**COUNTY OF SAN MATEO
PLANNING AND BUILDING DEPARTMENT**

SUBJECT: EXECUTIVE SUMMARY: Consideration of a Coastal Development Permit, and Design Review Permit, pursuant to Sections 6328.4 and 6565.3 of the San Mateo County Zoning Regulations, respectively, to allow construction of a new 1,632 sq. ft. two-story single-family residence, plus a 459 sq. ft. attached garage, located on a 5,949 sq. ft. legal parcel. No trees are proposed for removal. The project is appealable to the California Coastal Commission.

County File Number: PLN 2018-00391 (Love)

Site Plan

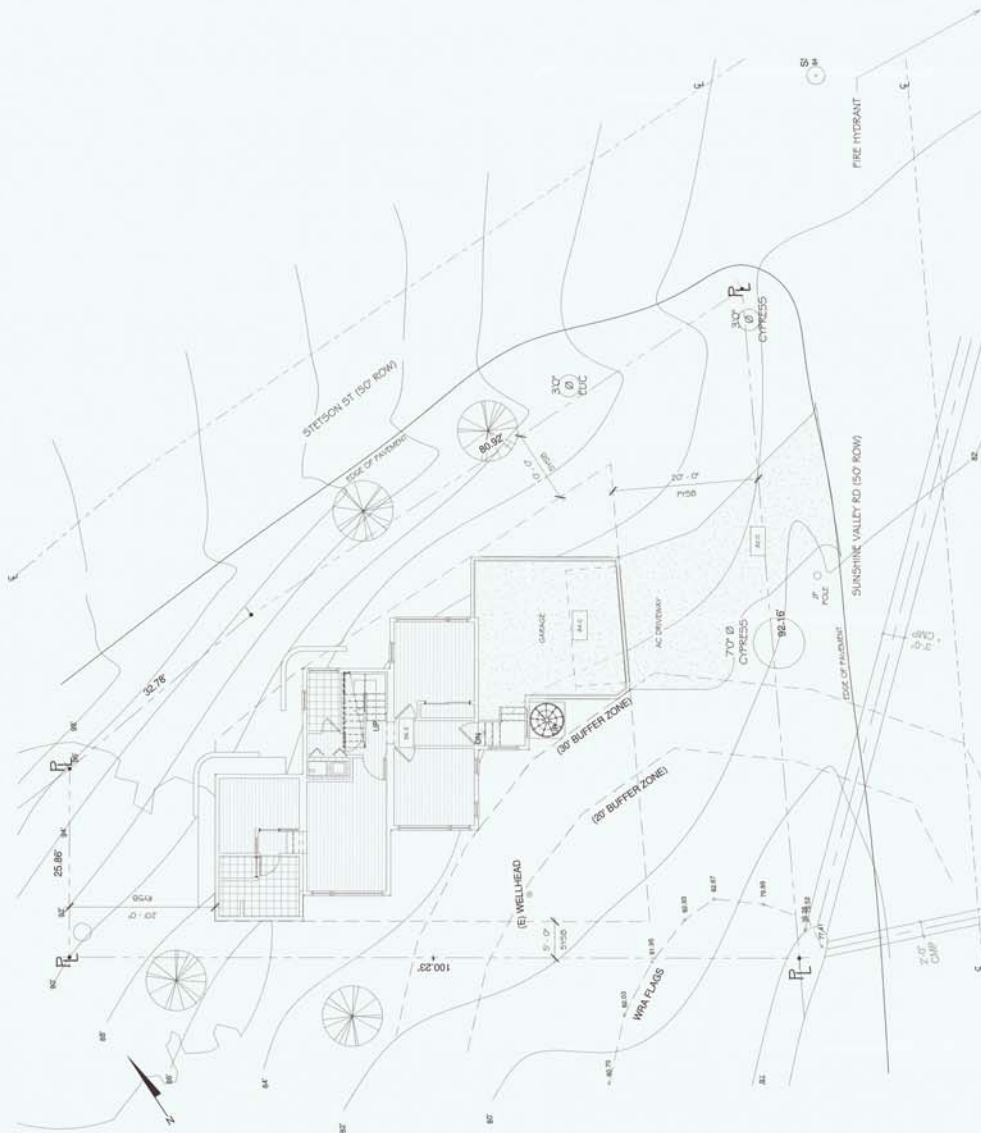
22. A building permit is required for this submittal.
23. Prior to the issuance of the building permit, the applicant shall have prepared, by a registered civil engineer, a drainage analysis of the proposed project and submit it to the Building Inspection Section for review and approval. The drainage analysis shall consist of a written narrative and a plan. The flow of the stormwater onto, over, and off of the property shall be detailed on the plan and shall include adjacent lands as appropriate to clearly depict the pattern of flow. The analysis shall detail the measures necessary to certify adequate drainage. Post-development flows and velocities shall not exceed those that existed in the pre-developed state. Recommended measures shall be designed and included in the improvement plans and submitted to the Building Inspection Section for review and approval.

26. Survey plan shall call out the creek name and show banks including required setbacks at building permit stage, not just the flow line.
27. Because of the existence of the creek, the site is subject to shallow ground water table, which limits the design of the drainage system and must be addressed at building permit stage.
